Objection to Planning Application P/11/0465/PPP Rumah, Reddingmuirhead.

Application Comments for P/11/0465/PPP

PLANNING APPLICATION DETERMINED BY DIRECTOR OF DEVELOPMENT SERVICES UNDER DELEGATED POWERS – REPORT OF HANDLING

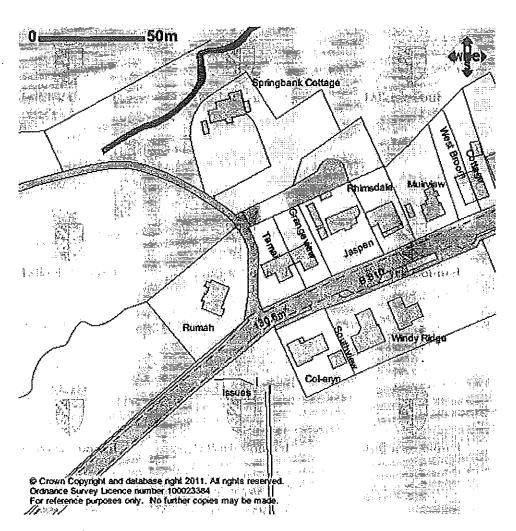
would you be able to provide details of damage-only accidents in the area described in the title? The location of the access is shown in the sketch below:

Sorry for delay. Our records show only one damage only outside the dwelling house known as Sandaig E291092 N677615 which is east of junction.
